Access Compliance Report

Public Rights-of-Way

Intersection ID: 4886	Main Street: OLD_STATESVILLE_RD	Cross Street: OAK_DR	Location:	E
ADA ID: E3C27C1D403E	Ramp Type: Perp	Initial Pass/Fail: Fail	Overall Compliance: No	Severity Score: 10
Codes/Mitigation Info/Possible Solution		Field Measurements/Component Compliance

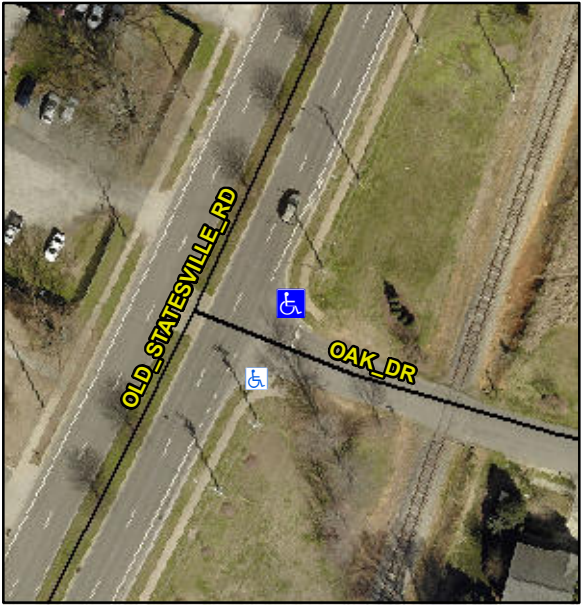
Possible Solutions:						
	Remove & Replace Entire Ramp.	N/A	Ramp Length (in)	60.0	Yes	Ramp Slope (%)	8.2
		No	Ramp Width (in)	36.0	No	Ramp XSlope (%)	2.5
		N/A	Flare Type LT	N/A	N/A	Flare Type RT	N/A
		N/A	Flare Slope LT (%)	N/A	N/A	Flare Slope RT (%)	N/A
		N/A	Flare Traversable LT?	N/A	N/A	Flare Traversable RT?	N/A
		N/A	Landing Length (in)	N/A	N/A	DWS Provided?	N/A
		N/A	Landing Width (in)	N/A	N/A	DWS Contrast?	N/A
		N/A	Landing Slope (%)	N/A	N/A	DWS Length (in)	N/A
		N/A	Landing X Slope (%)	N/A	N/A	DWS Full Width?	N/A
		N/A	Landing Curb? (Y/N)	N/A	N/A	DWS Offset (in)	N/A
		N/A	Shared Landing?	N/A			
		N/A	Gutter Ponding?	N/A	N/A	Gutter Slope (%)	N/A
		N/A	Gutter Lip Ht (in)	N/A	N/A	Gutter X Slope (%)	N/A
		N/A	Painted X Walk1?	No	N/A	Painted X Walk2?	N/A
			X Walk 1 Direction	To SW		X Walk 2 Direction	N/A
		N/A	X Walk 1 Width (in)	N/A	N/A	X Walk 2 Width (in)	N/A
			X Walk 1 Slope (%)	1.0		X Walk 2 Slope (%)	N/A

X Walk 1 X Slope (%)	1.1		X Walk 2 X Slope (%)	N/A
		N/A	Ramp inside XWalk1?	N/A	N/A	Ramp inside XWalk2?	N/A
<p>Surveyor Notes:</p> <p>N/A</p> <p>PROW/ADA:</p> <p>Not Found, R304.5.1, R304.5.3</p>		N/A	Road Slope (%)	N/A	N/A	Clear Space?	N/A
		N/A	Road X Slope (%)	N/A	N/A	Clear Space to XWalk (in)	N/A
		N/A	Any Obstructions?	N/A	N/A	Storm Grate/Utility Hazard?	N/A
			Obstruction Type			Storm Grate/Utility Type	
					N/A		N/A
					Yes	Surface Condition? (G/P)	Good
Total Cost:		\$	1850.00
